LINE	QUANTITY	UOP	CAT NO	ITEM NUMBER	UNIT PRICE	AMOUNT
***** ADDENDUM NO. 1 *****						
ADDENDUM ISSUED FOR THE THREE FORK CREEK WATERSHED PROJECT TO DISTRIBUTE THE PRE-BID SIGN-IN SHEETS, THE REVISED BIS SCHEDULE, THE ADDITIONAL DRAWINGS, AND THE Q/A RESULTING FROM THE MANDATORY PRE-BID MEETING ON 04/28/2010.						
BID OPENING DATE AND TIME REMAIN UNCHANGED AS 05/26/10 AT 1:30 PM.						
***** NO OTHER CHANGES *****						
0001	1	JB		962-73		
RECLAMATION: RESTORATION OF LAND & OTHER PROPERTIES

Addendum #1 - Questions During Pre-Bid Meeting

Three Fork Creek Stream Restoration

ADDENDUM NO. 1

GATE DETAIL

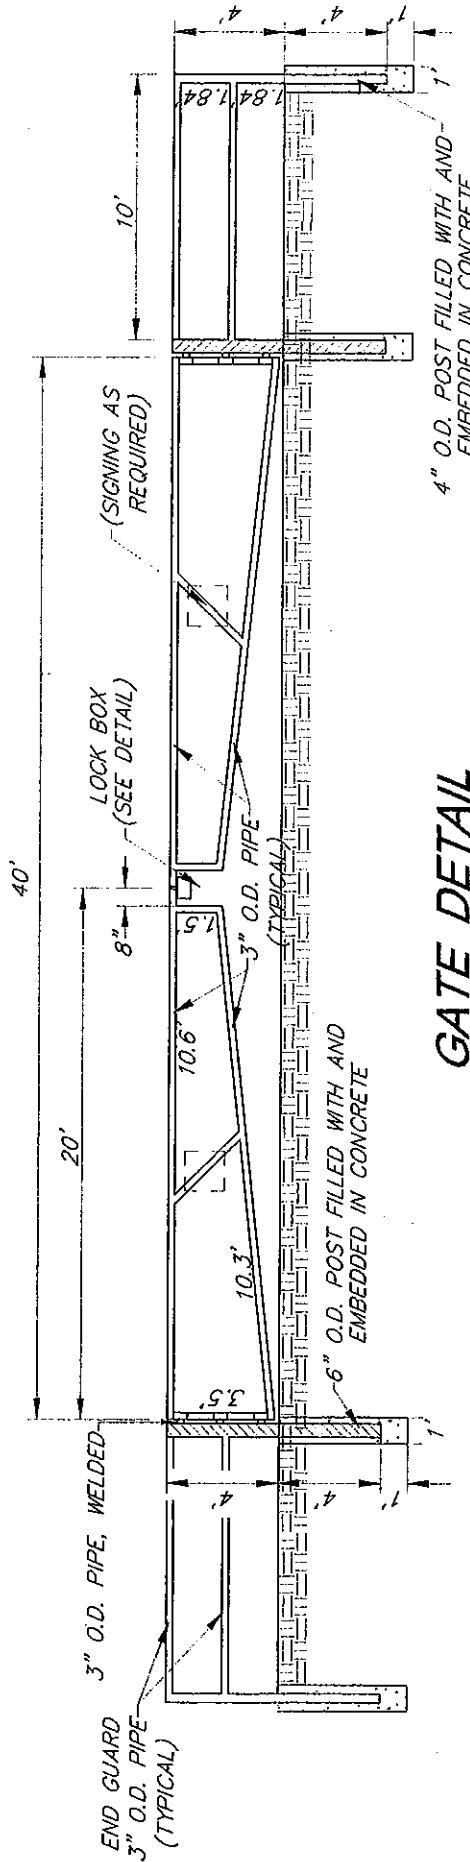
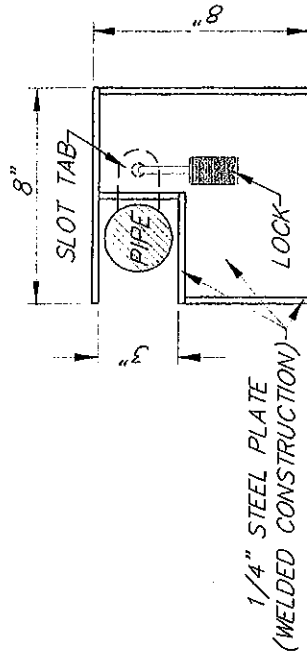
2. There is a gate required to be installed at the North Bird's Creek site. The gate detail and the gate location are included with this addendum.
3. The following items are required by Patriot Mining Company as part of the Right of Entry agreements to use their access road.
